CONSTRUCTION DOCUMENTS CHICK-FIL-A POWERS & PALMER

CDs for public improvements only

Merrick comment response
noted in blue text box with
white background

PS1.1

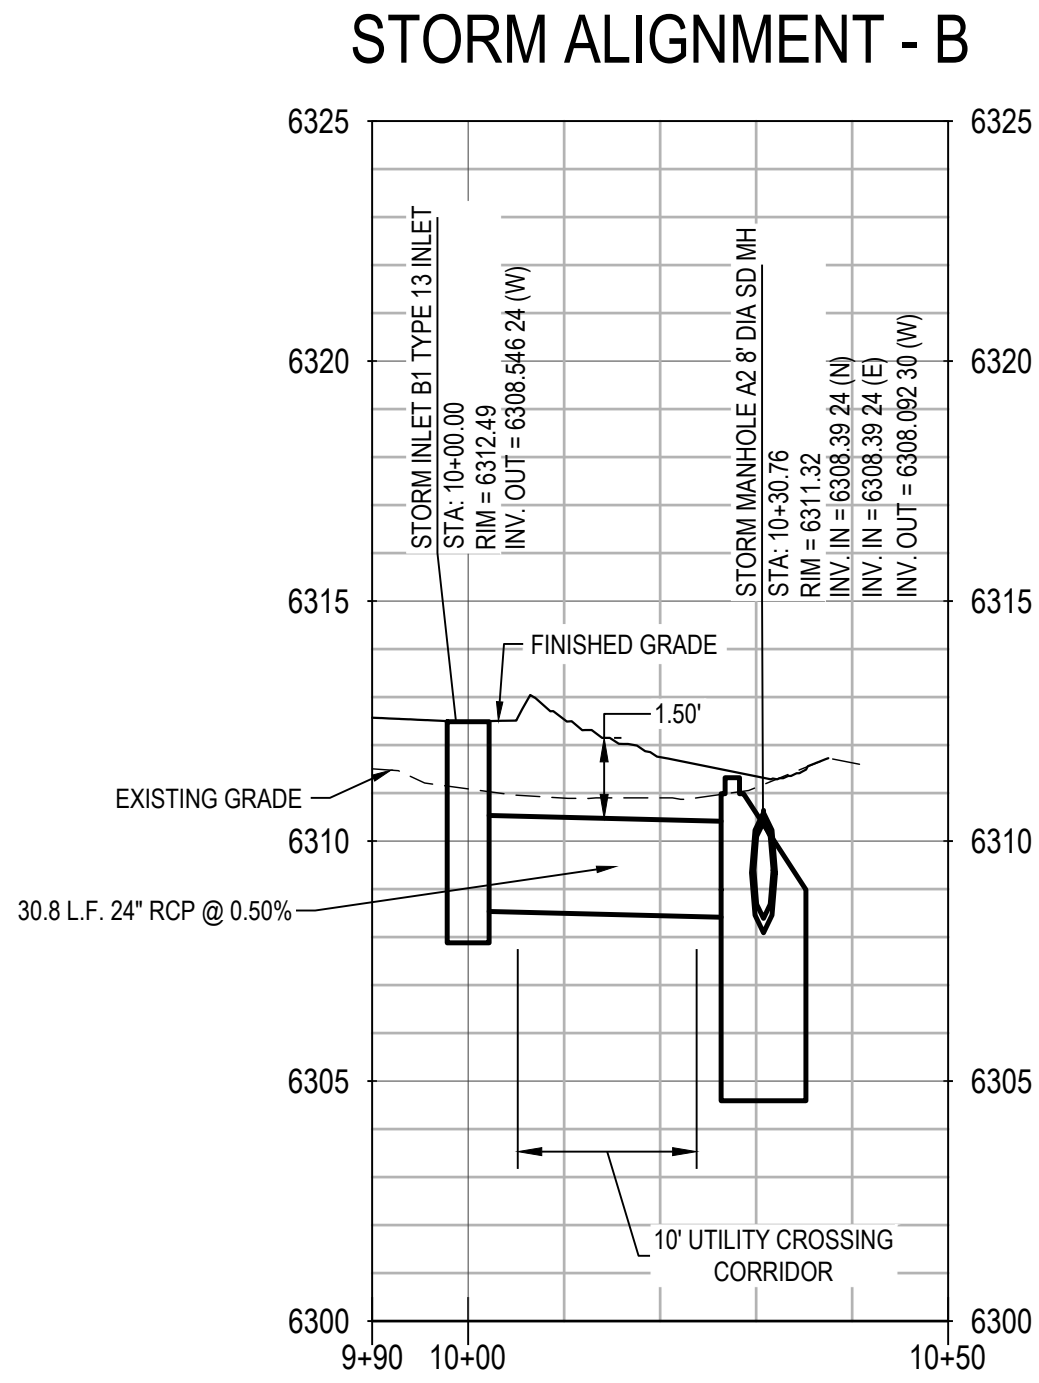
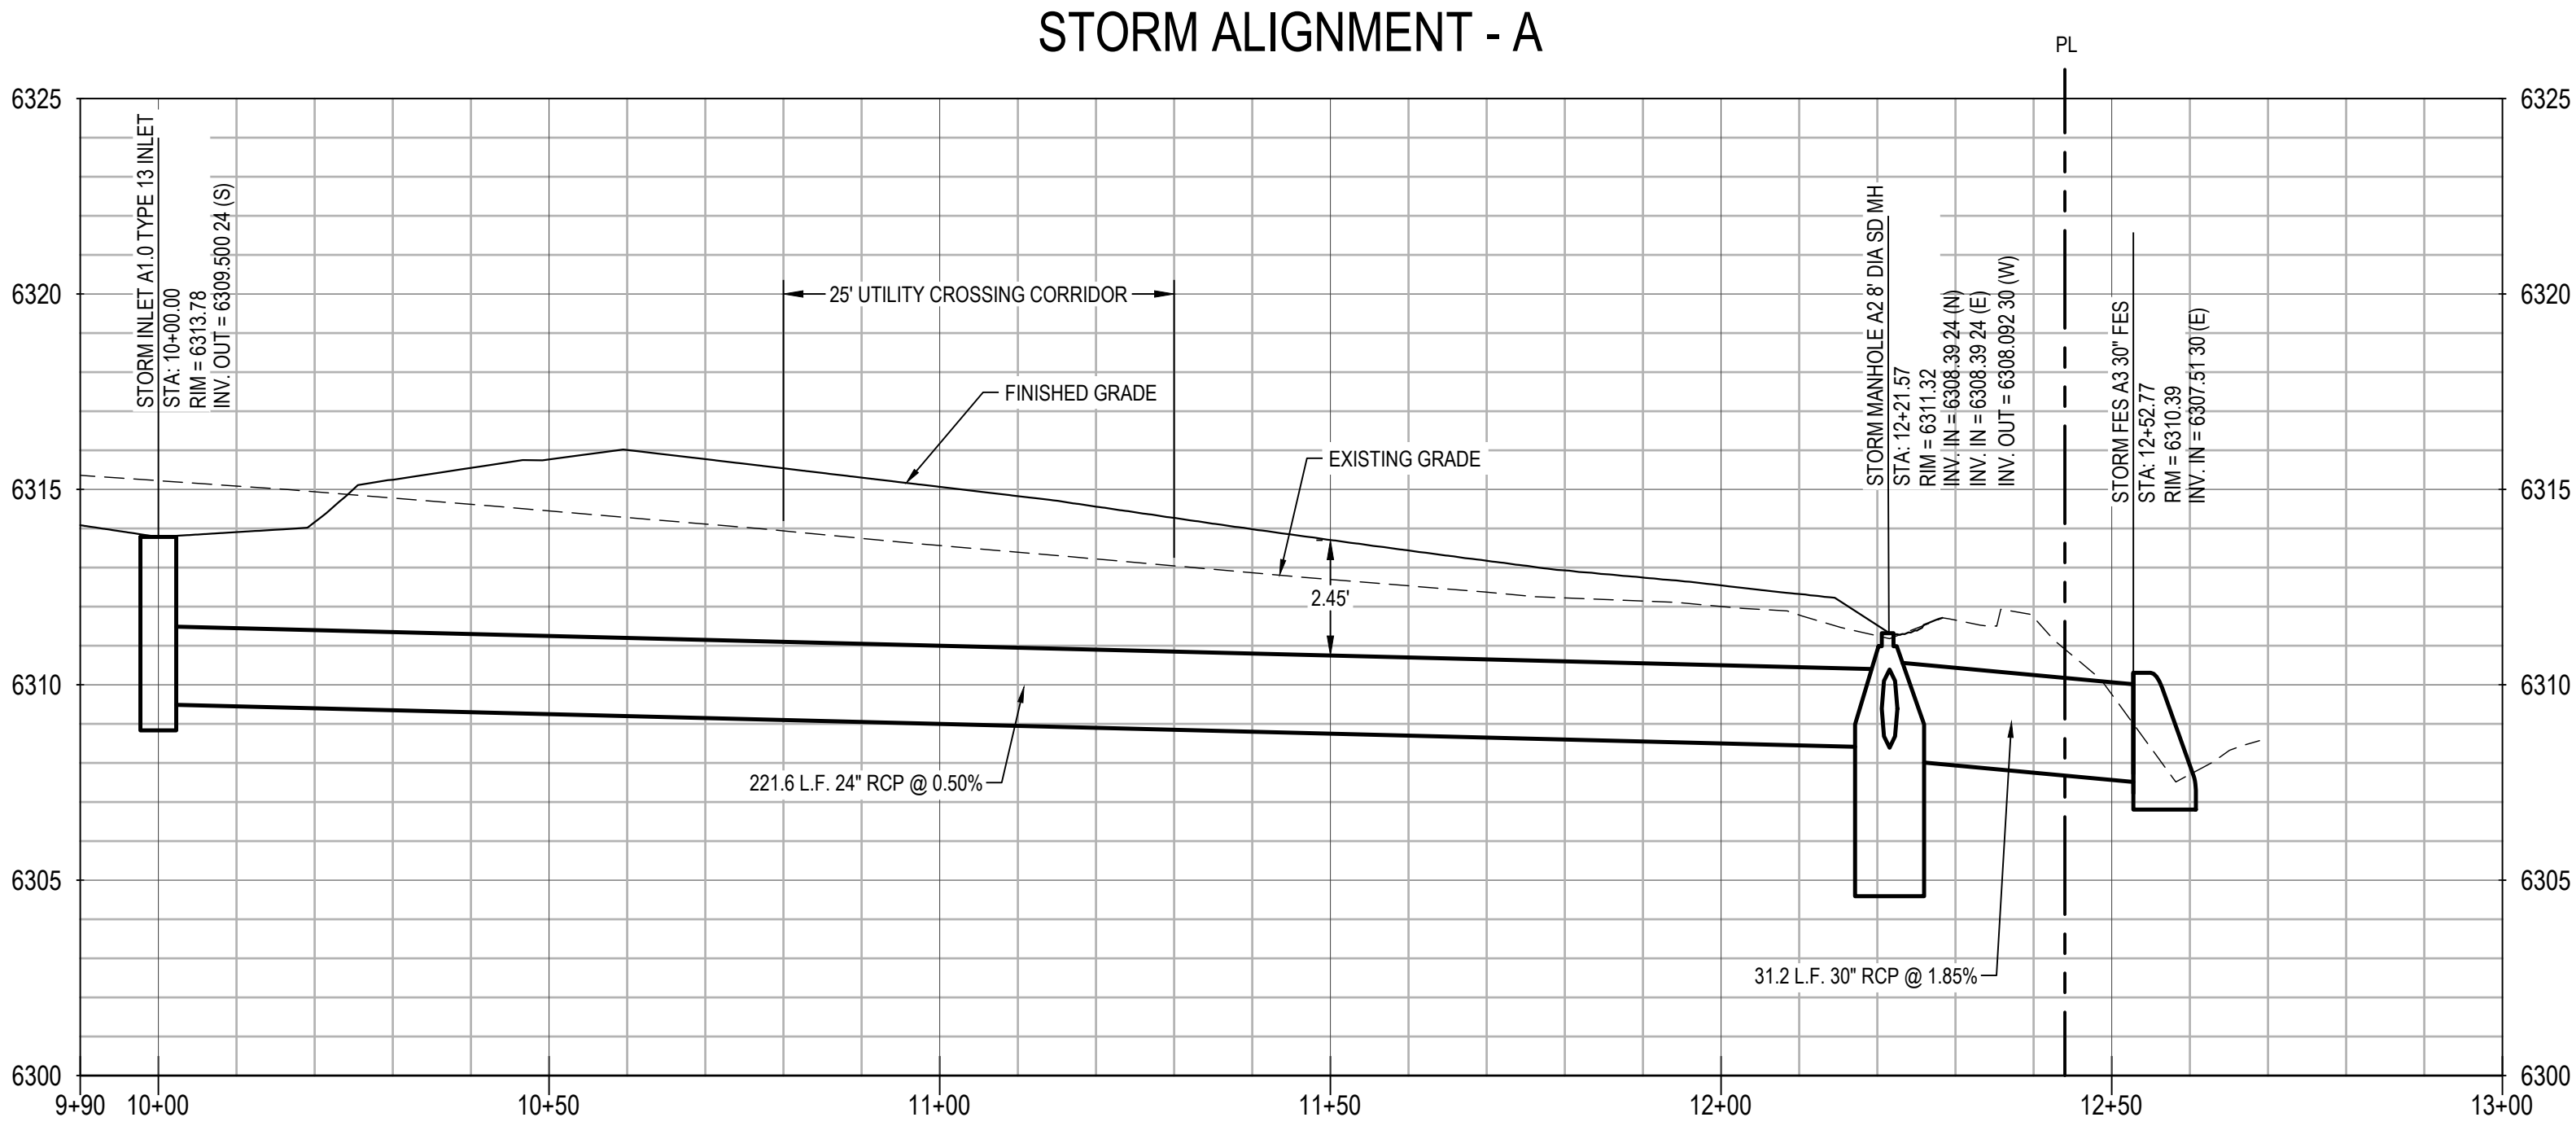
Place with GEC Plan set

Storm P&P Placed in GEC
Plan set - Page 5
